PEER REVIEW OF THE ARBORIST REPORT FOR SANTA BARBARA COTTAGE HOSPITAL

MEMORANDUM

SUBJECT: Peer Review of the Arborist Report for Santa Barbara Cottage Hospital

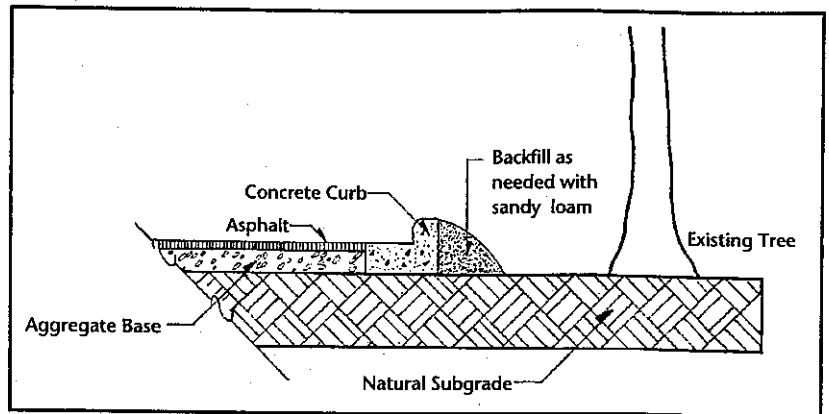
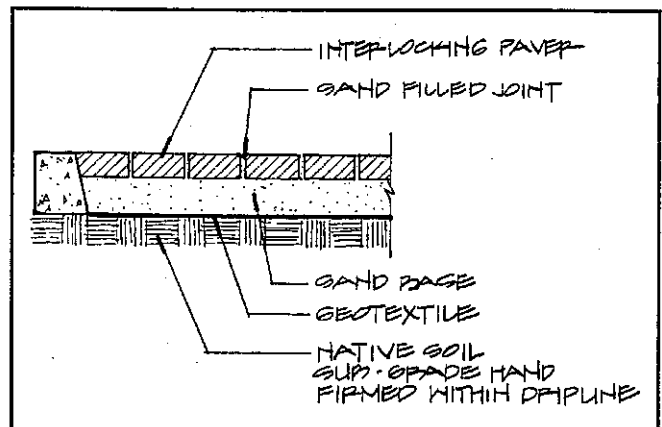
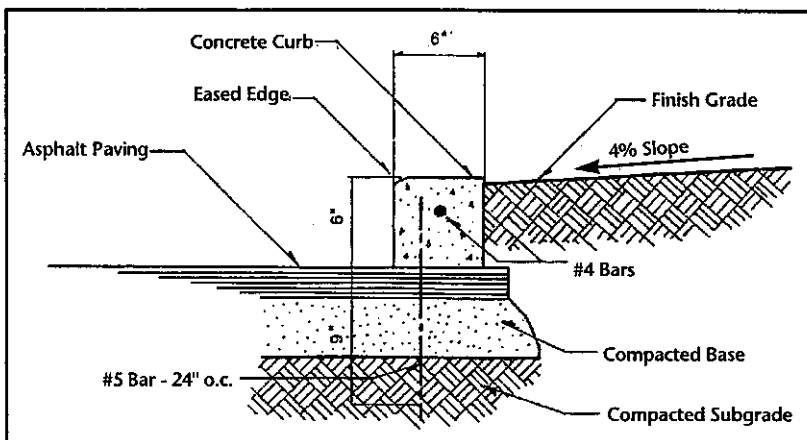
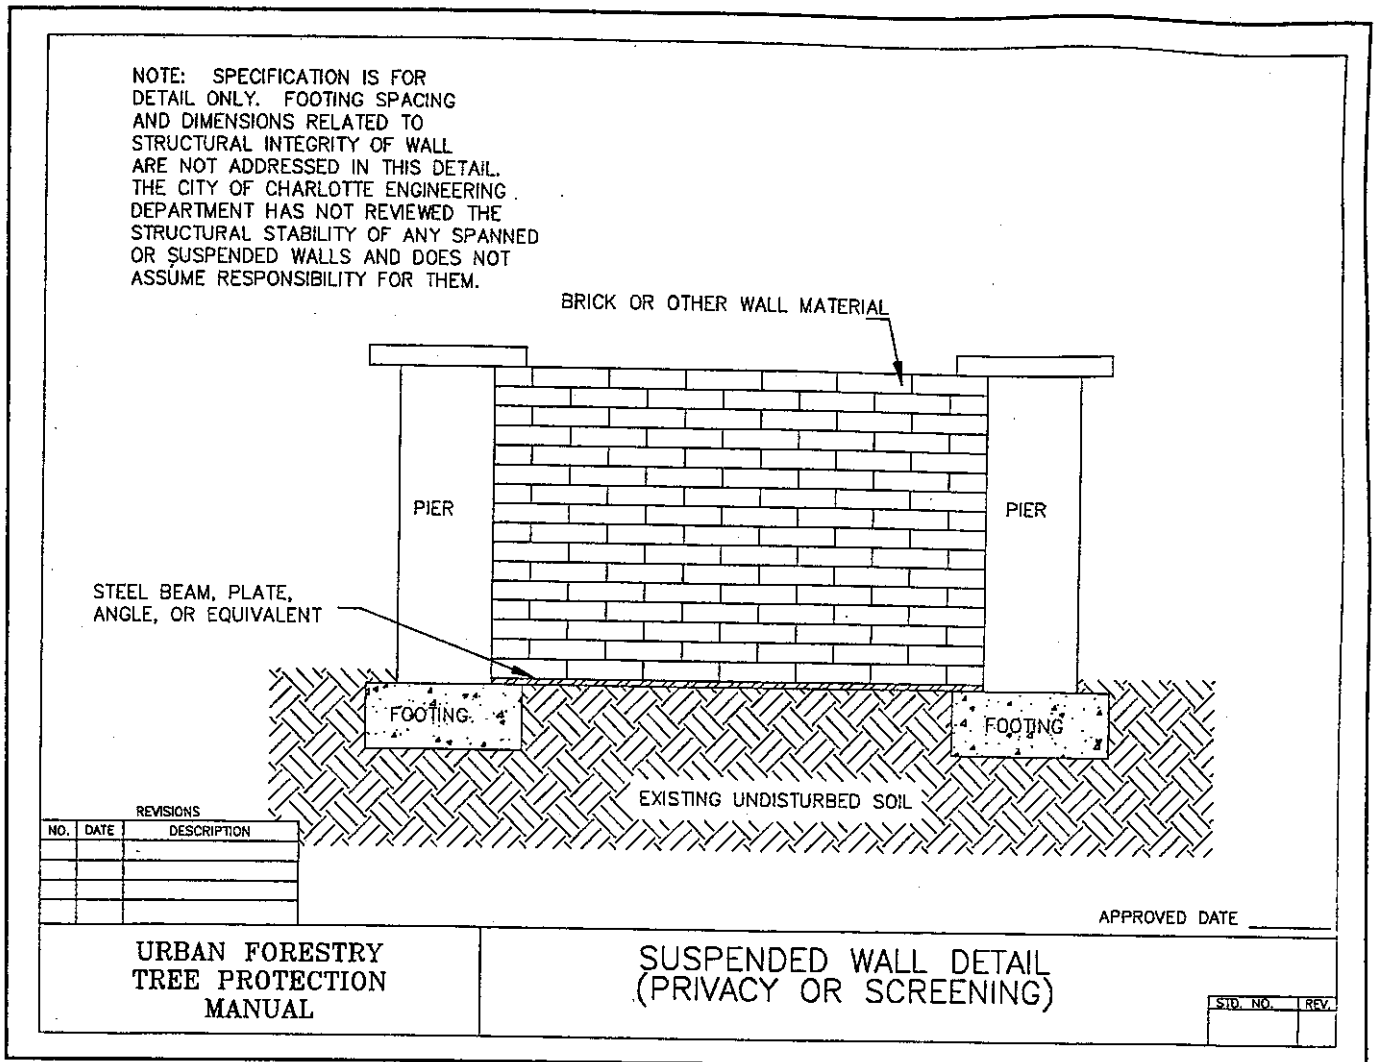
- Verification of the exact location of the tree (and root system) in reference to its surroundings and the proposed structures and hardscaping.
- Discussion of the species' relative tolerance to root disturbance and root pruning, and a discussion of how this fits with the mature specimen onsite. In particular, how the size, age and vigor of this tree may be affected in regard to the planned level of root removal and disturbance. Generally, no more than 20% of tree roots should be cut per year on a vigorous, healthy tree; root pruning is *not* recommended for older, stressed, or less vigorous trees. (Moreton Bay figs are vigorous as a species when they are young and have been planted in a favorable environment. This specimen, however, is mature and appears to be stressed due to the limited size of the planting space, soil compaction, lack of organic matter in the soil, etc.) The report should determine the extent of root pruning that could be allowed on this specimen, and discuss options to the proposed root pruning and modifications of the planned hardscaping such as bridging over roots, root tunneling, "no dig pavement", non-continuous footings, placing new curbs on top of existing pavement, etc. (See Figures 8.3, 8.4, 8.5, and 8.6 in the report appendix).
